## SINGAPOREAN NOTICES TO MARINERS

The monthly Notices to Mariners contain information required to keep charts and publications published by the Hydrographic Division, Maritime and Port Authority of Singapore up-to-date.

CORRECTION NO.	SNM EDN NO.	LAST CORR N NO.	CHART NO.	Location on Chart		
29 (1)	04	25	GSP1/SP1	X

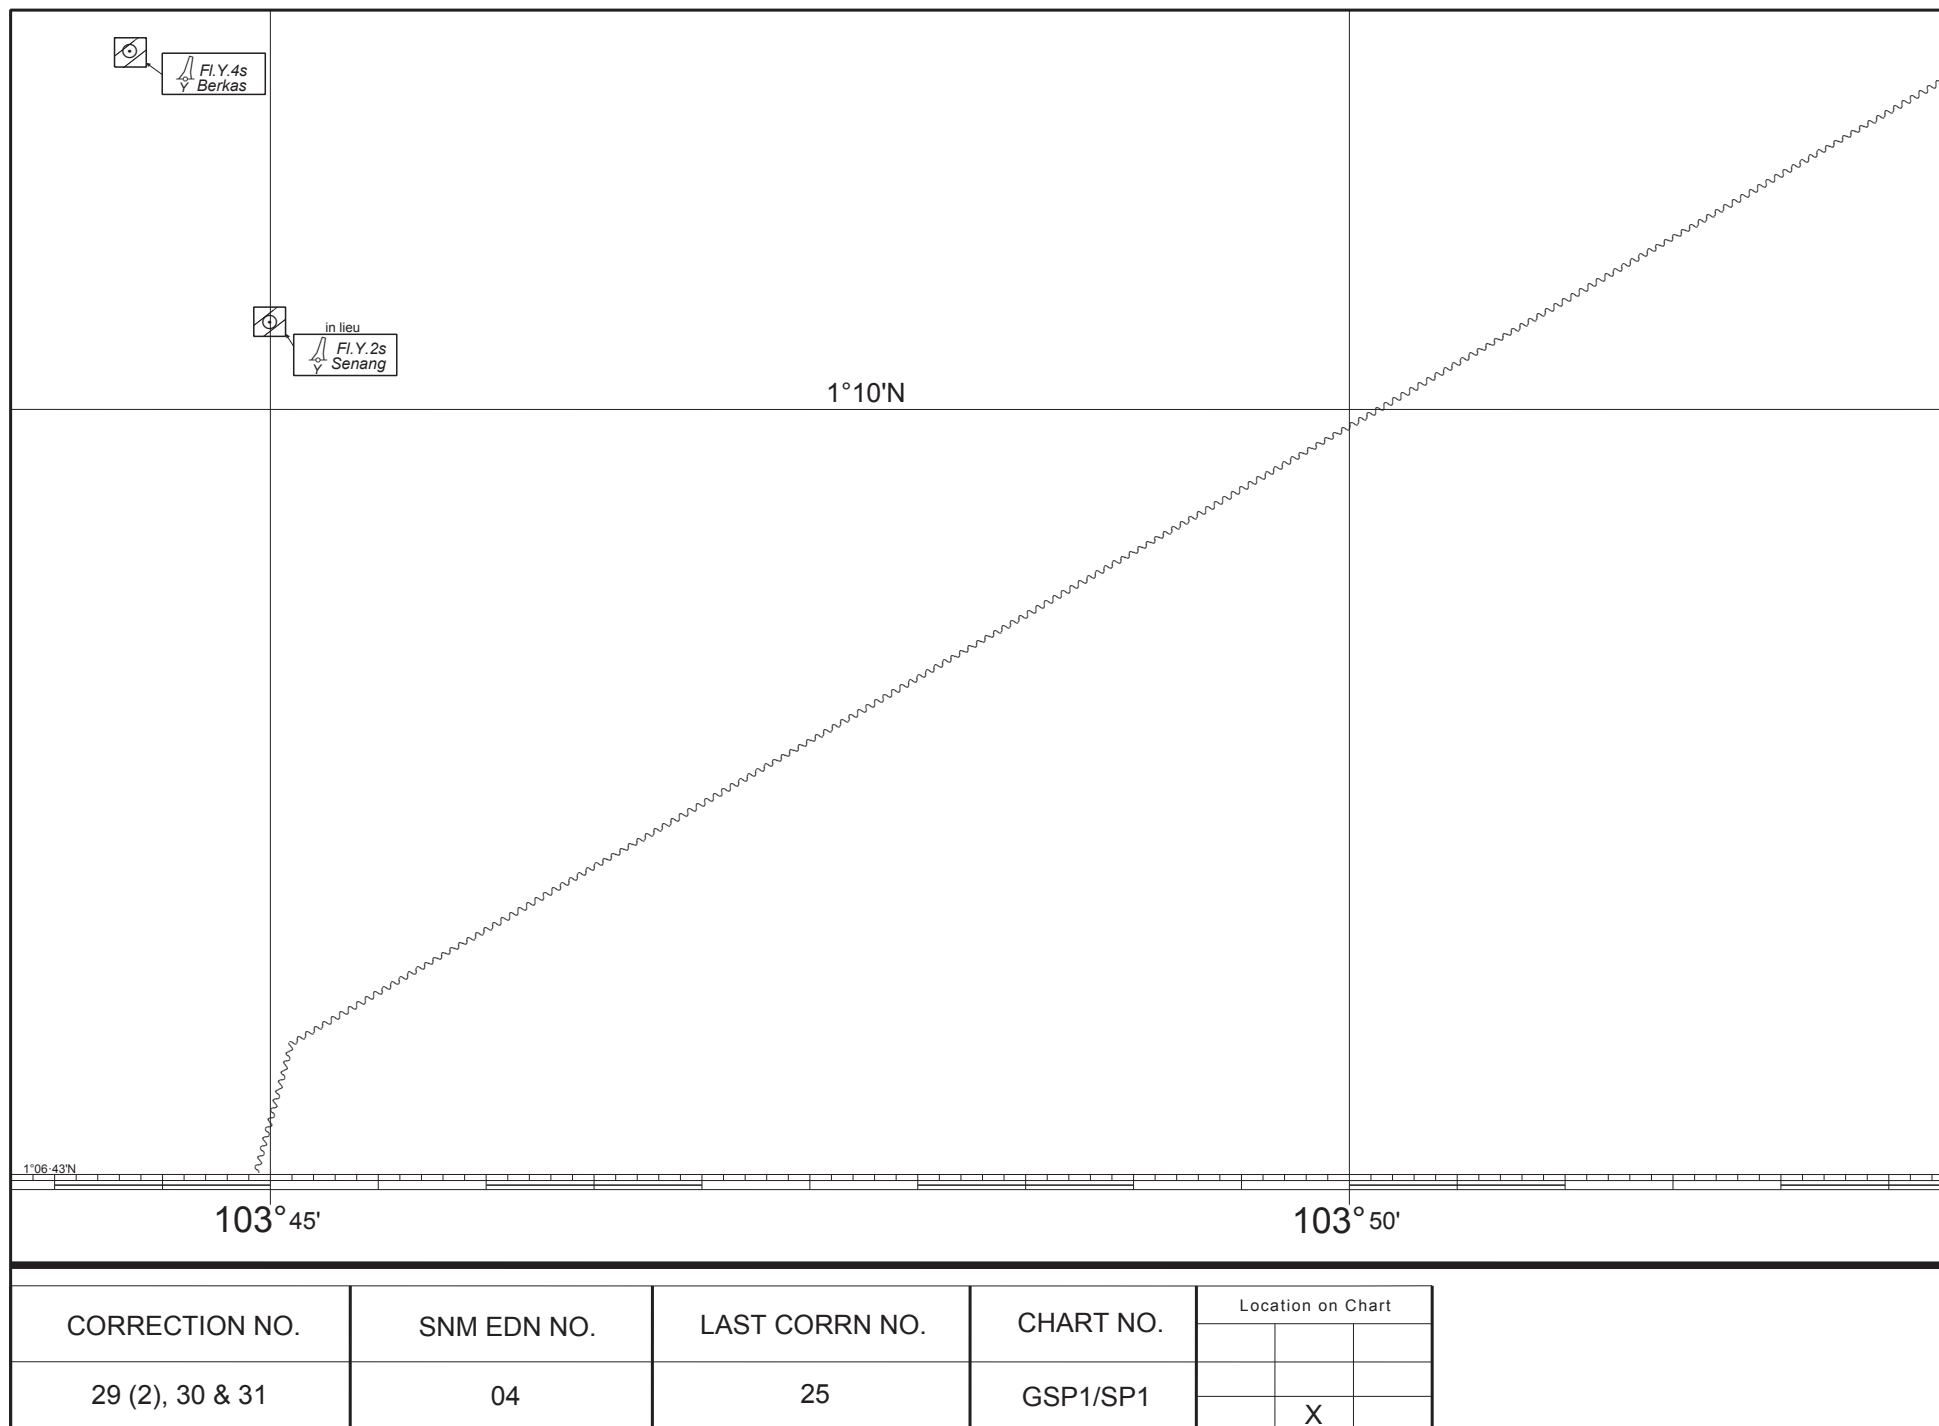
<b>GSP1/SP1</b>	9 Ed 15/01/25 Last NM 25/2025	(Maritime and Port Authority of Singapore)	<b>*NM 29/2025</b>
<b>Insert</b>	submarine cable,  , joining:	1°12·98'N 103°37·19'E 1°12·27'N 103°36·89'E 1°11·66'N 103°35·93'E 1°11·53'N 103°34·68'E 1°10·50'N 103°34·00'E (chart border)	
	and:	(chart border) 1°06·43'N 103°44·93'E 1°07·04'N 103°45·10'E 1°11·73'N 103°53·08'E 1°13·56'N 103°57·64'E 1°14·59'N 104°05·00'E 1°14·31'N 104°08·10'E (chart border)	
		(Maritime and Port Authority of Singapore)	<b>*NM 30/2025</b>
<b>Replace</b>	 <i>Senang, Fl. Y. 2s</i> with  <i>Senang, Fl. Y. 2s</i>	1°10·41'N 103°45·00'E	
		(Maritime and Port Authority of Singapore)	<b>*NM 31/2025</b>
<b>Replace</b>	 <i>Berkas, Fl. Y. 4s</i> with  <i>Berkas, Fl. Y. 4s</i>	1°11·67'N 103°44·35'E	
		(Pushidrosal Indonesian Notice No.10/95/2025)	<b>NM 32/2025</b>
<b>Move</b>	 <i>LFl. 10s</i> , from:	1°10·24'N 103°59·31'E	
	to:	1°10·14'N 103°58·48'E

CORRECTION NO.	SNM EDN NO.	LAST CORR N NO.	CHART NO.	Location on Chart		
34 & 35	04	33	202	X

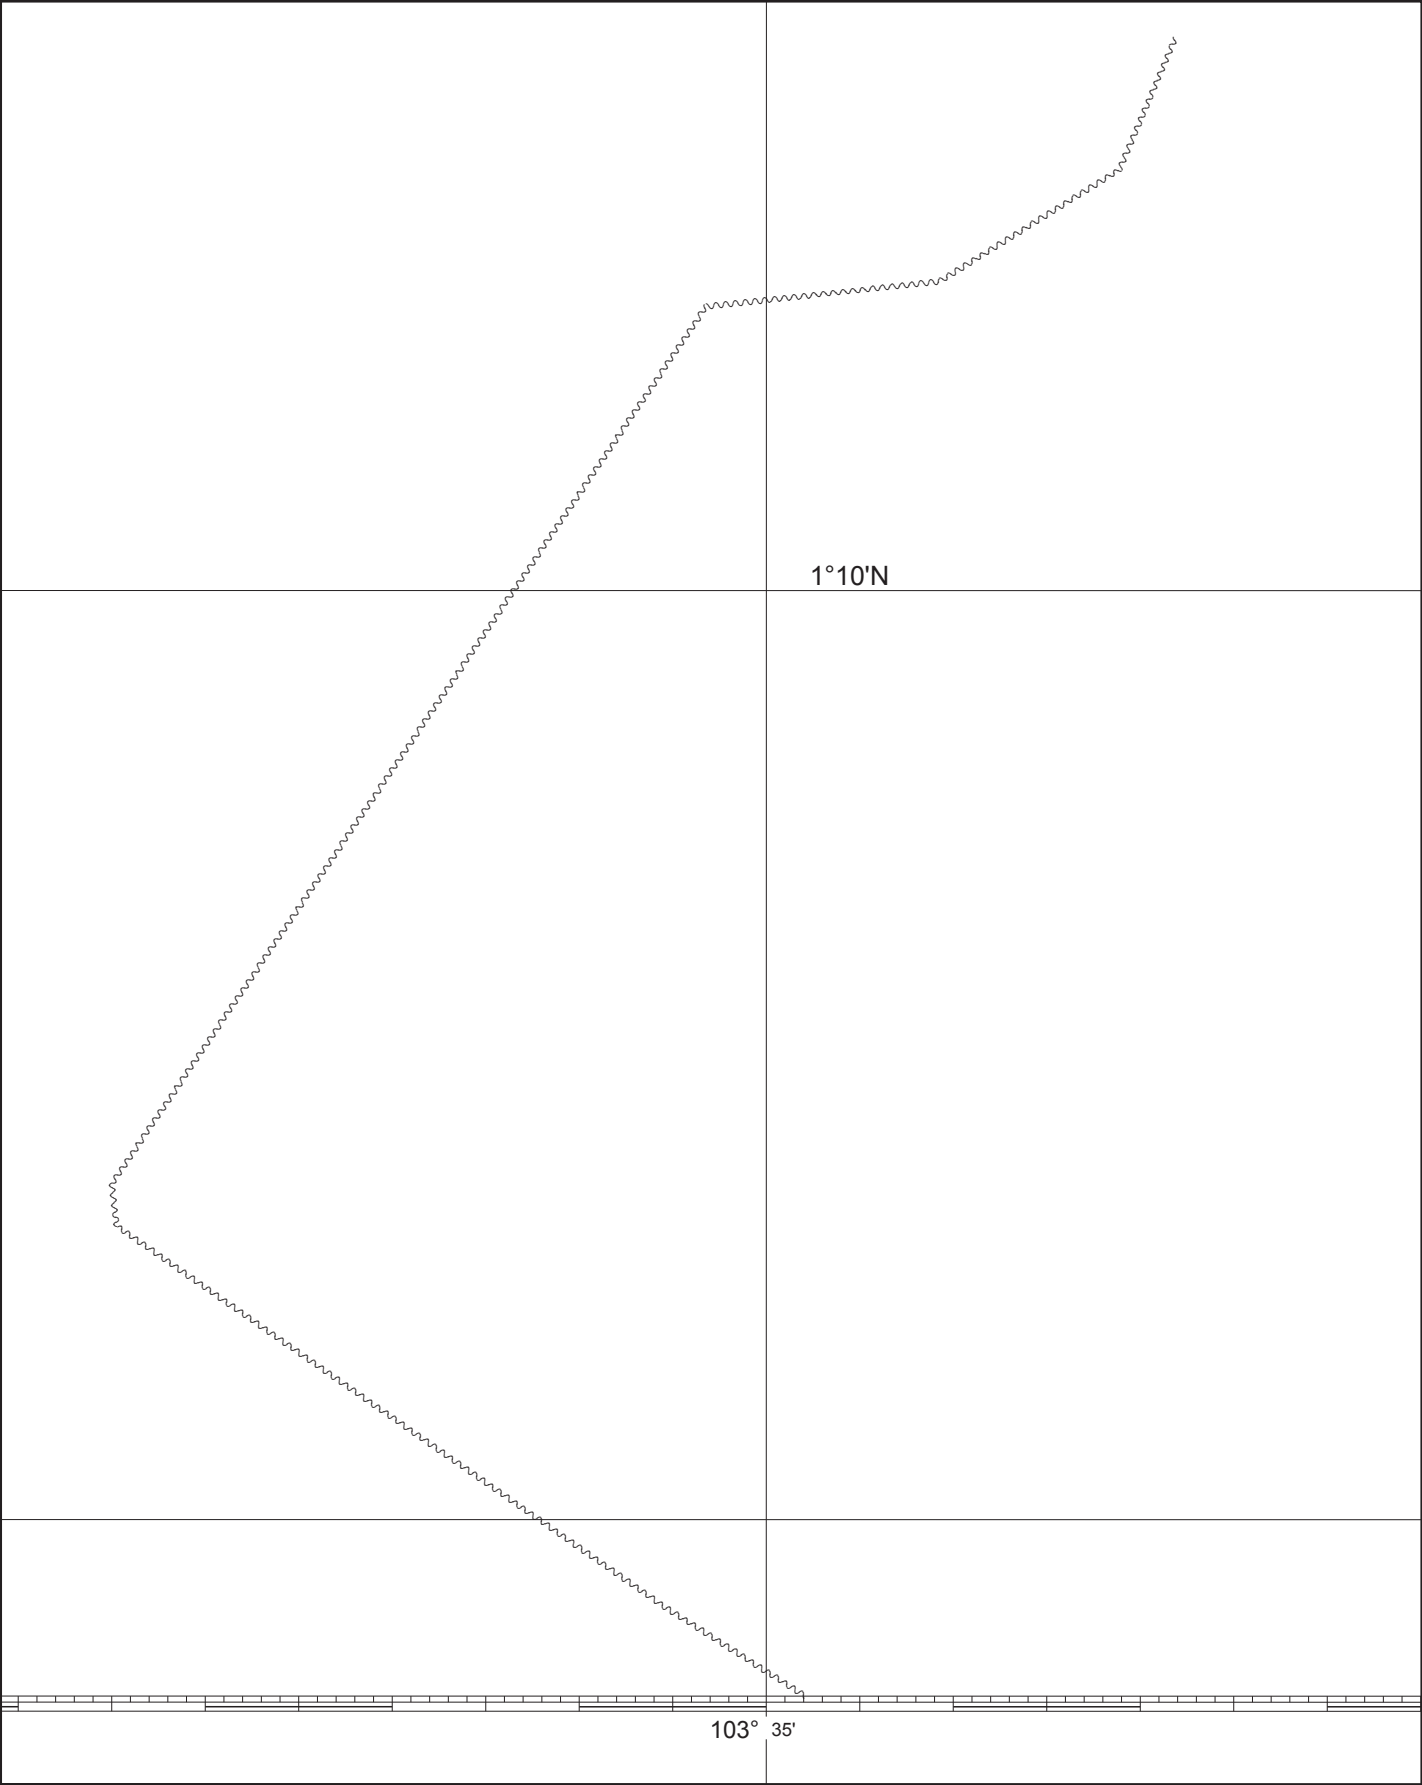
<hr/>			
<b>202</b>	8 Ed 15/09/16 Last NM 5/2025	(Maritime and Port Authority of Singapore)	<b>*NM 29/2025</b>
<b>Insert</b>	submarine cable,  , joining:	(chart border) 1°18·53'N 104°38·17'E 1°18·64'N 104°38·60'E 1°18·90'N 104°40·30'E 1°17·42'N 104°44·00'E 1°15·63'N 104°48·89'E (chart border)	
		(Pushidrosal Indonesian Notice No.10/94/2025)	<b>NM 33/2025</b>
<b>Insert</b>	 <i>Wk</i>	1°16·72'N 104°28·41'E	
		(Pushidrosal Indonesian Notice No.8/76/2025)	<b>NM 34/2025</b>
<b>Insert</b>	depth, <i>19<sub>8</sub></i> and associated 20m contour	0°53·24'N 103°36·58'E	
	depth, <i>19<sub>3</sub></i> and associated 20m contour	0°52·74'N 103°34·41'E	
		(Pushidrosal Indonesian Notice No.8/75/2025)	<b>NM 35/2025</b>
<b>Delete</b>	depth, <i>13</i> and associated 10m contour	0°57·65'N 103°34·04'E

CORRECTION NO.	SNM EDN NO.	LAST CORR N NO.	CHART NO.	Location on Chart		
29 (2)	04	25	500			X

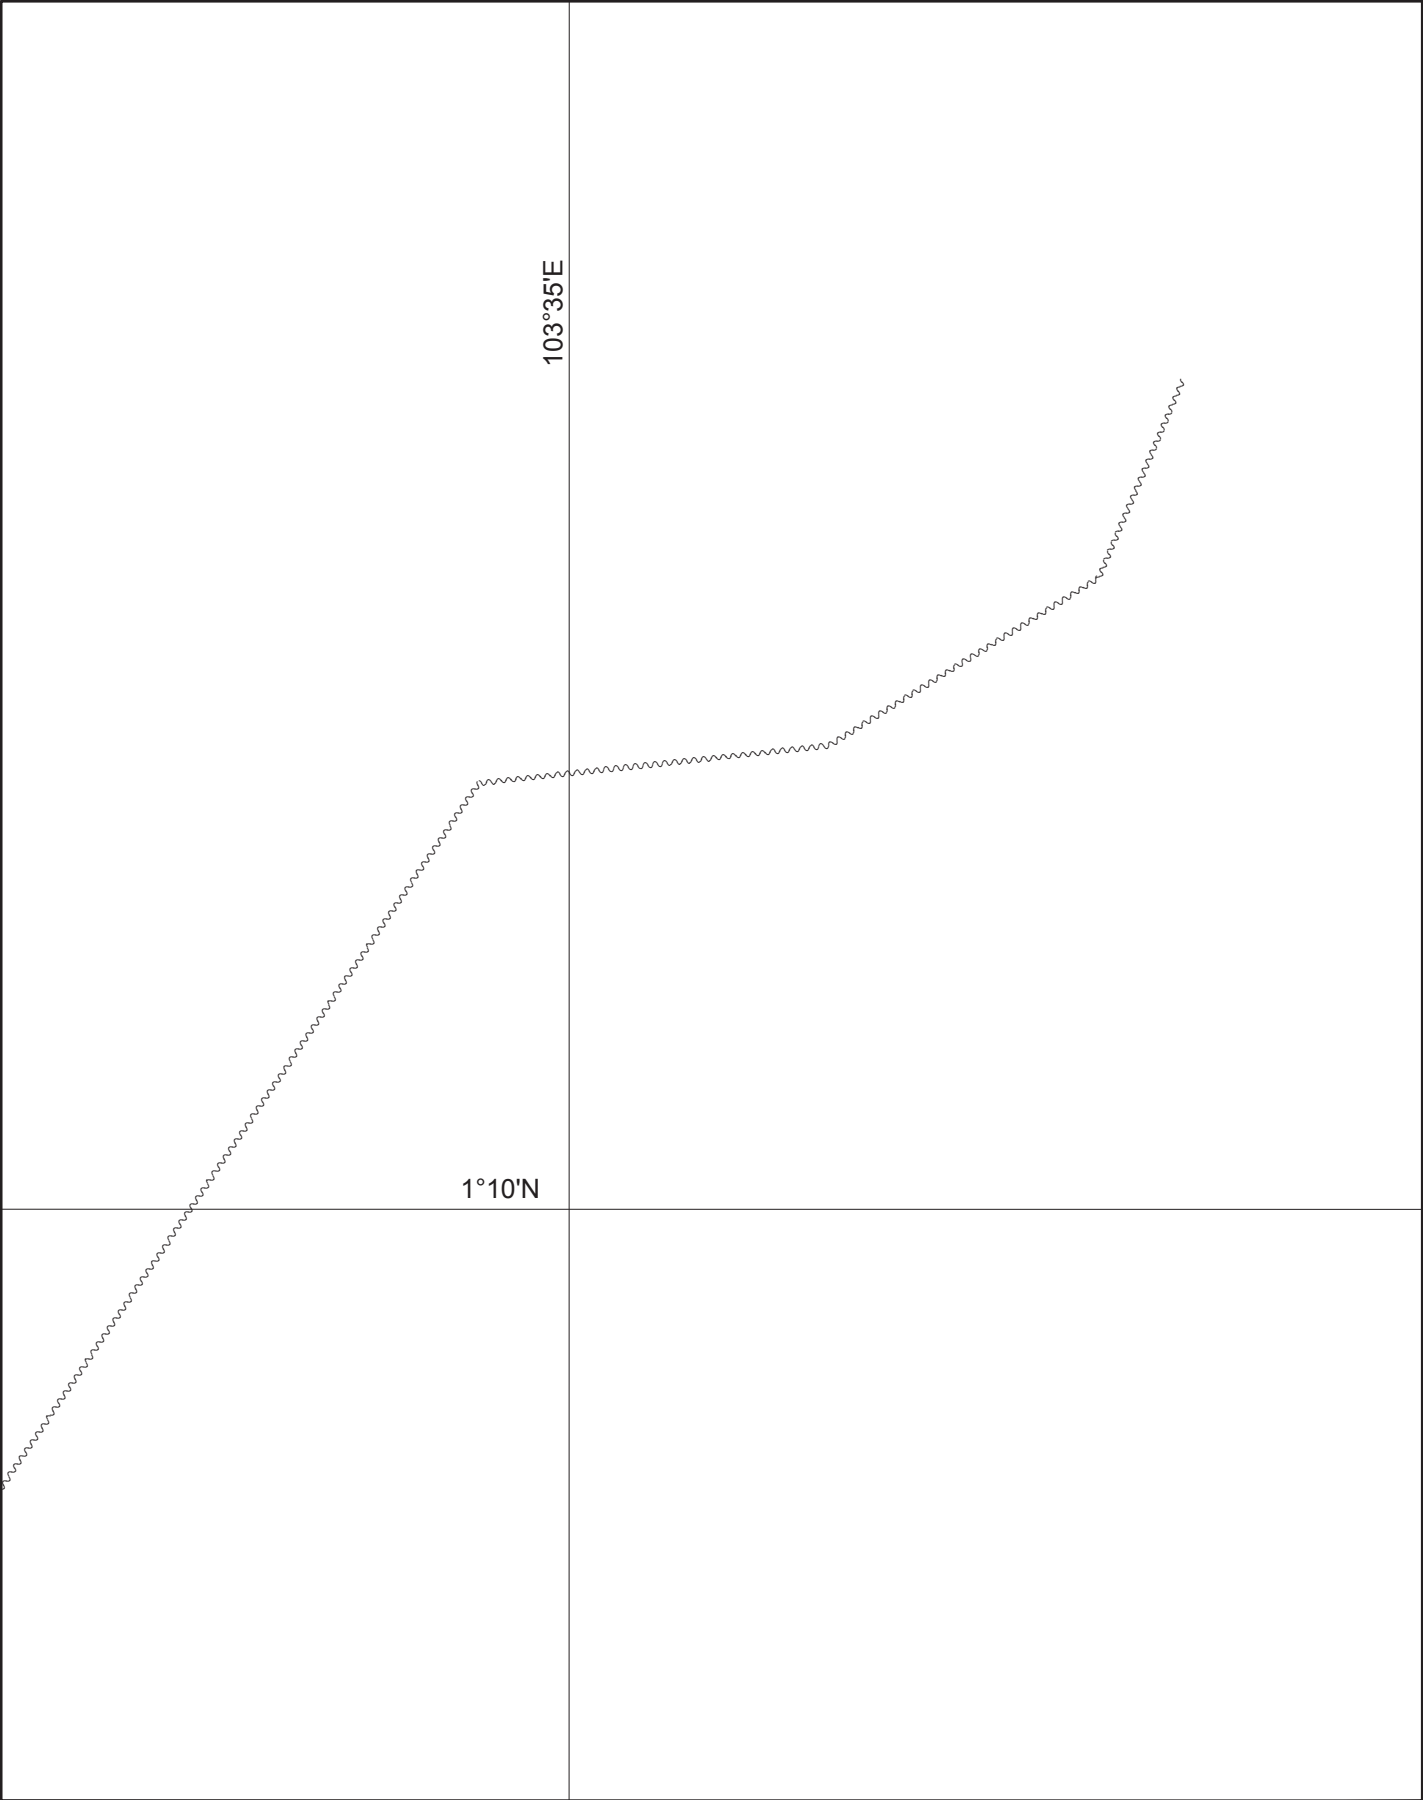
<b>500</b>	8 Ed 15/09/17 Last NM 25/2025	(Maritime and Port Authority of Singapore)	<b>*NM 29/2025</b>
<b>Insert</b>	submarine cable,  , joining:		1°12·98'N 103°37·19'E
			1°12·27'N 103°36·89'E
			1°11·66'N 103°35·93'E
			1°11·53'N 103°34·68'E
			1°06·81'N 103°31·50'E
			1°06·58'N 103°31·53'E
			1°04·53'N 103°34·46'E
			1°04·05'N 103°35·21'E
			(chart border)
	and:		(chart border)
			1°04·05'N 103°42·64'E
			1°05·79'N 103°44·61'E
			(chart border)

CORRECTION NO.	SNM EDN NO.	LAST CORR N NO.	CHART NO.	Location on Chart		
				X		
29 (1)	04	26	501

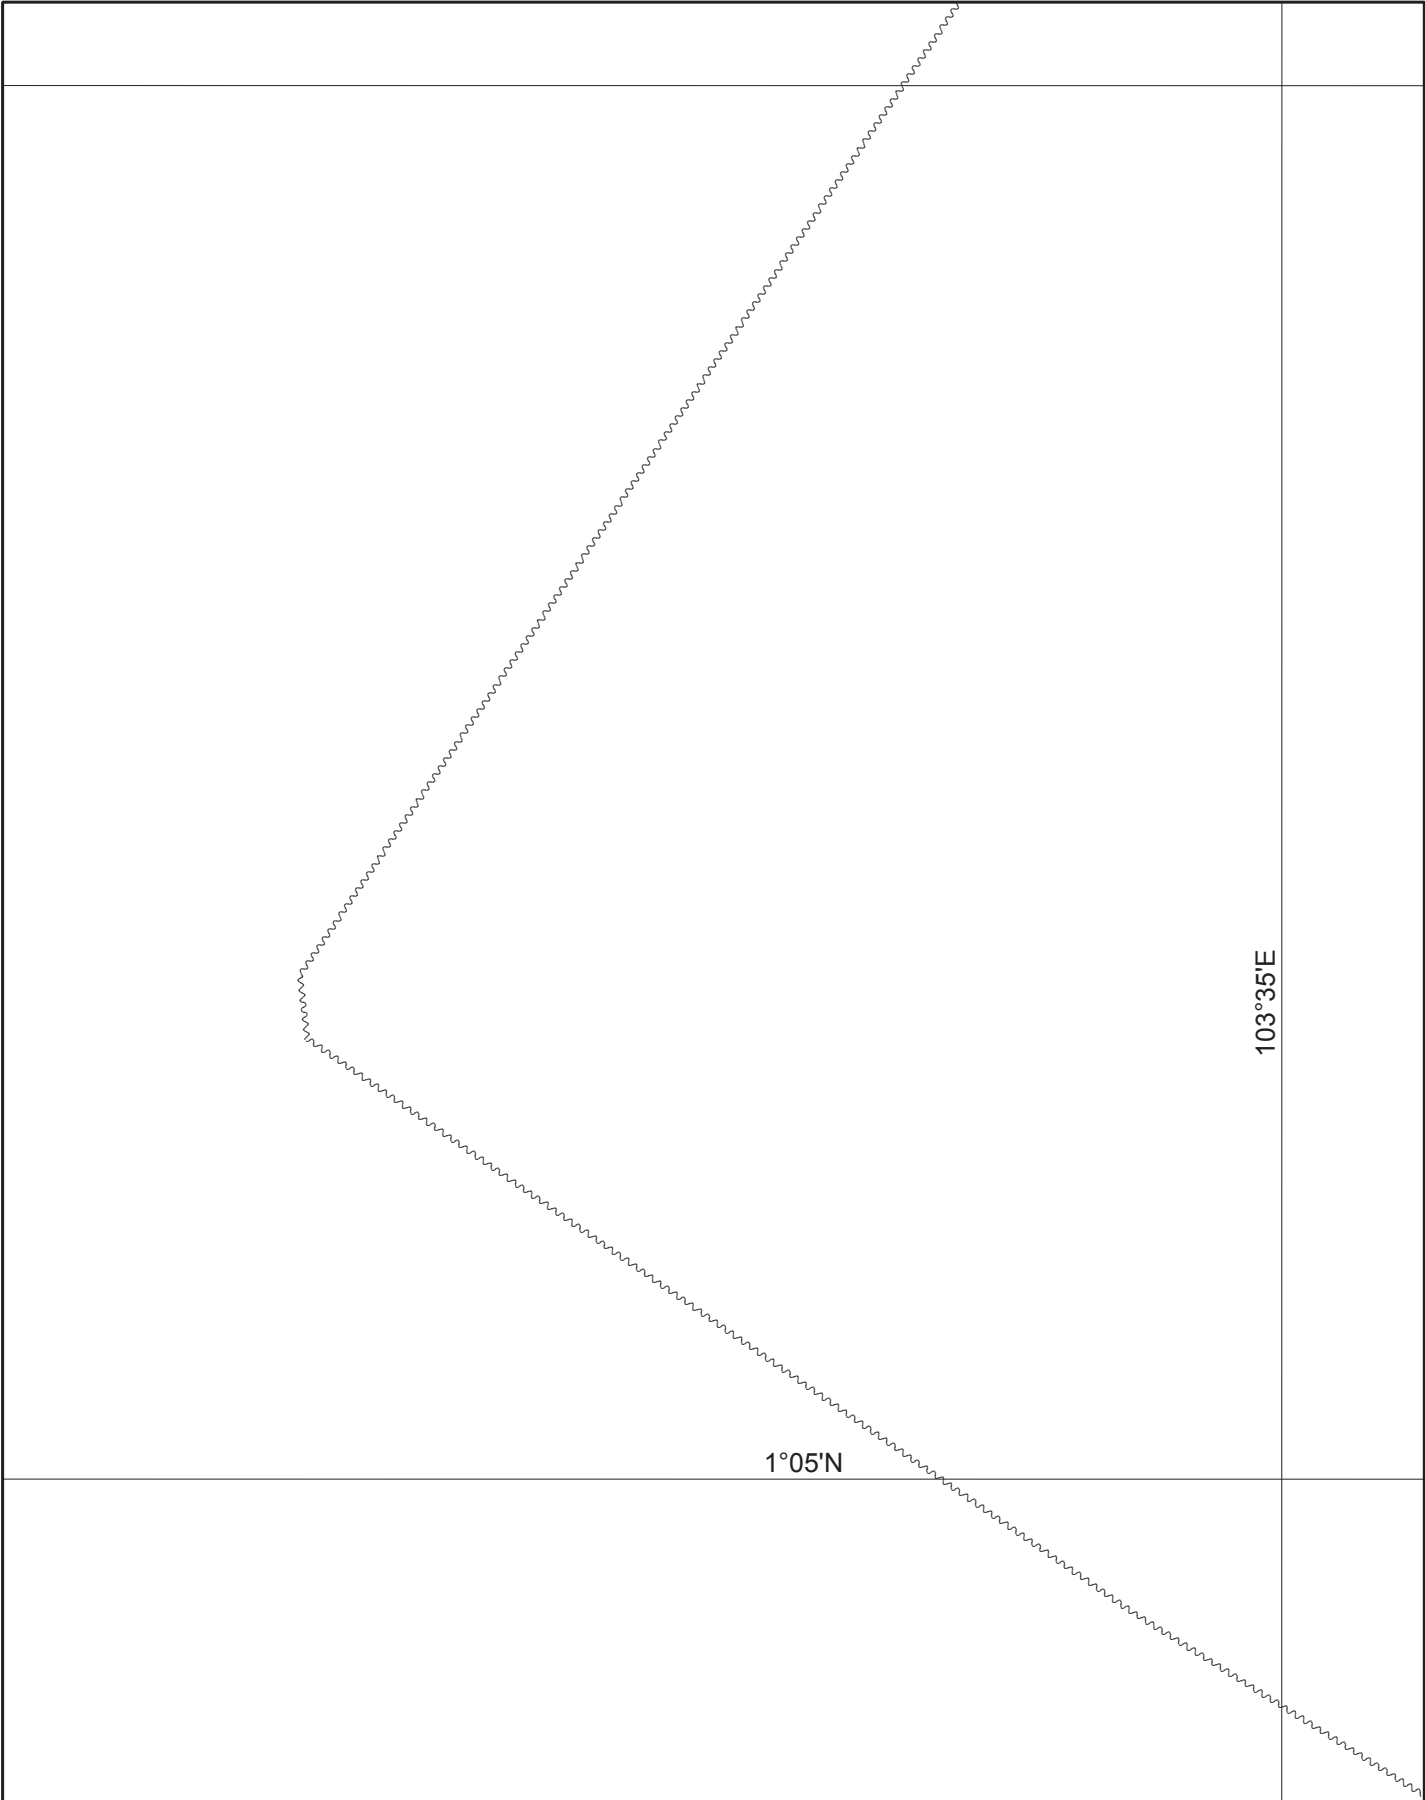
<b>501</b>	7 Ed 01/09/15 Last NM 26/2025	(Maritime and Port Authority of Singapore)	<b>*NM 29/2025</b>
<b>Insert</b>	submarine cable,  , joining:		1°12·98'N 103°37·19'E
			1°12·27'N 103°36·89'E
			1°11·66'N 103°35·93'E
			1°11·53'N 103°34·68'E
			1°06·81'N 103°31·50'E
			1°06·58'N 103°31·53'E
			1°04·53'N 103°34·46'E
			1°01·79'N 103°38·79'E
			1°01·66'N 103°39·53'E
			1°01·80'N 103°40·10'E
			1°05·94'N 103°44·80'E
			1°07·04'N 103°45·10'E
			1°11·73'N 103°53·08'E
			1°12·52'N 103°55·05'E
			(chart border)
